Origination Form
Proposed Revisions to a Standard Plans Index

Originator:	Gray, Ryan	Index Number:	711-003
Date:	8/6/2025	Sheet Number(s):	6
E-mail:	ryan.gray@dot.state.fl.us	Index Title:	Interchange Markings

Summary of the changes:

LAST REVISION 11/01/21	DESCRIPTION: 11/01/25	FDOT FY 2025-26 STANDARD PLANS	INTERCHANGE MARKINGS	INDEX 711-003	SHEET 6 of 8
------------------------------	--------------------------	--------------------------------------	----------------------	------------------	-----------------

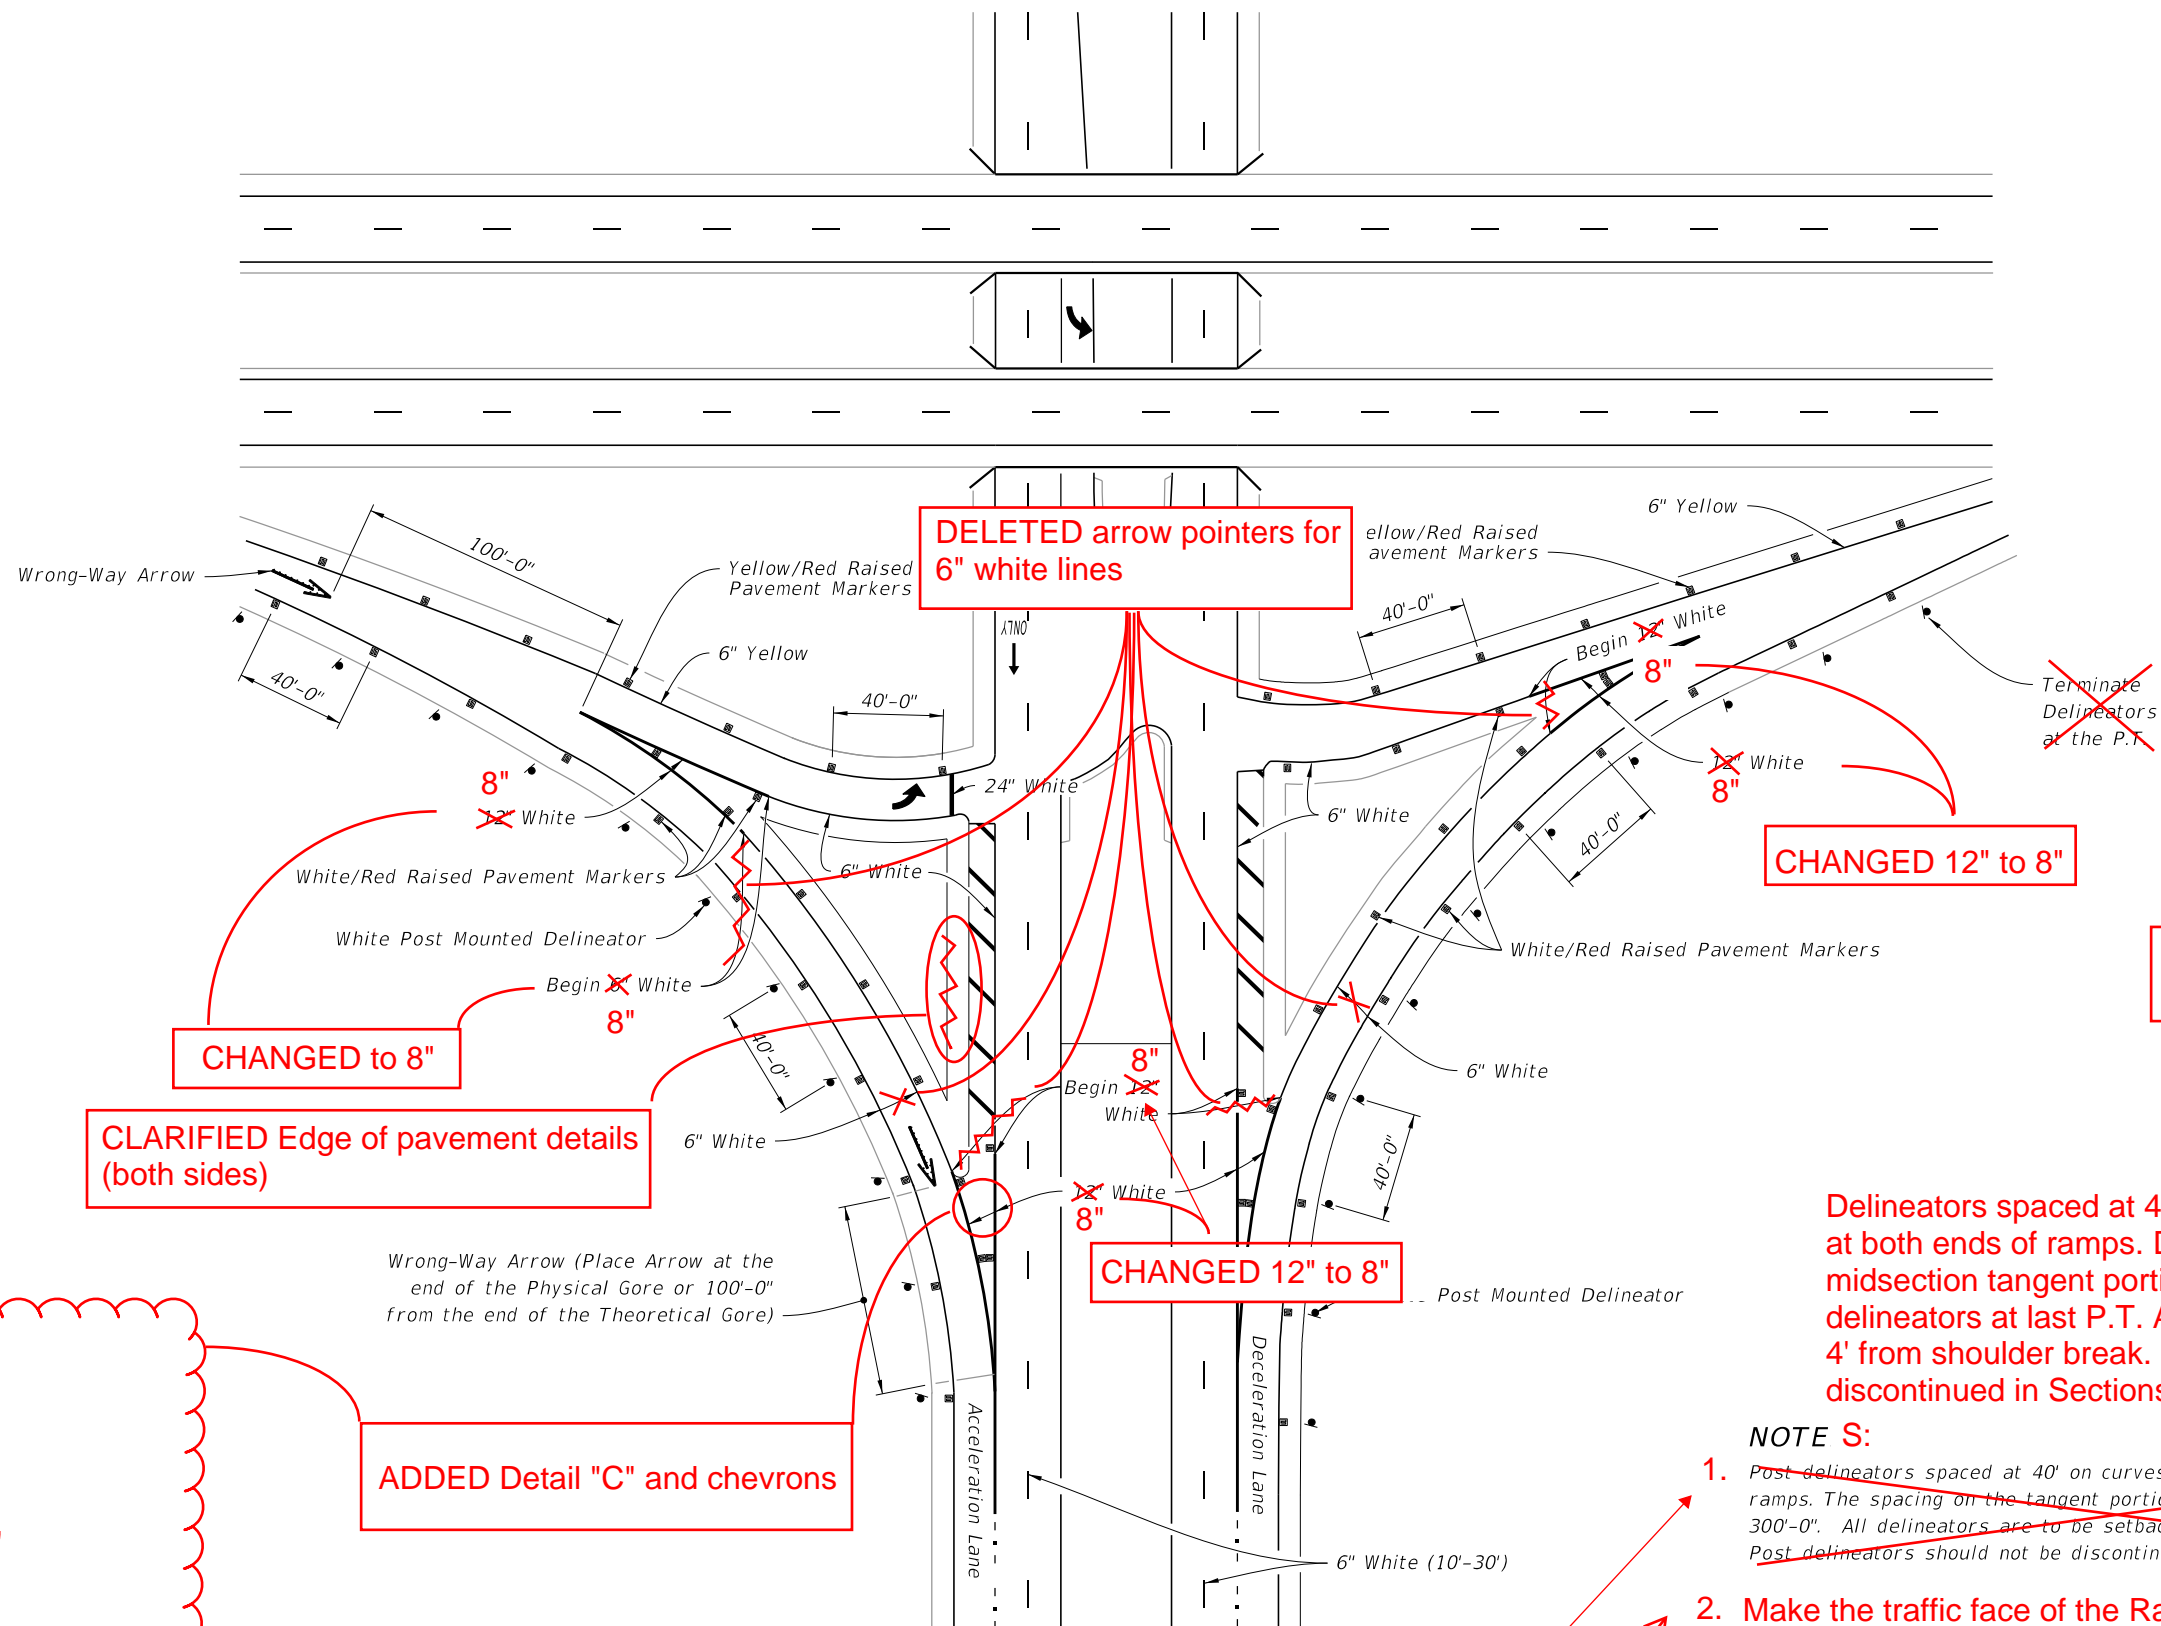
Sheet 6: DELETED arrow pointers for 6" white lines; CHANGED 12" to 8"; UPDATED Note 1; ADDED Note 2; ADDED Detail "C"; ADDED chevron markings to gores; CLARIFIED edge of pavement details.

For traffic passing to the right of the gores at the collector ends of ramps, the inside edge line adjacent to the physical gore should be a wide white line, or a yellow edgeline, to be consistent with MUTCD guidance. Added Note 2 to clarify RPM color for either channelizing/edgeline option; Updated Note 1 to clarify delineator spacings and termination point; Added chevrons and related Detail "C".

DELETED arrow pointers for 6" white lines

CHANGED 12" to 8"

UPDATED Note 1

CHANGED to 8"

CLARIFIED Edge of pavement details (both sides)

CHANGED 12" to 8"

ADDED Detail "C" and chevrons

ADDED Note 2.

Delineators spaced at 40' in curves (from P.C. to P.T.) at both ends of ramps. Delineator spacing on the midsection tangent portion of ramps is 300'. Terminate delineators at last P.T. All delineators are to be setback 4' from shoulder break. Delineators should not be discontinued in Sections with guardrail.

- NOTE S:**
- ~~Post delineators spaced at 40' on curves of the entrance and exit of ramps. The spacing on the tangent portion of the ramp section is 300'-0". All delineators are to be setback 4' from shoulder break. Post delineators should not be discontinued in sections with guardrail.~~
 - Make the traffic face of the Raised Pavement Marker the same color as the pavement marking it is supplementing.
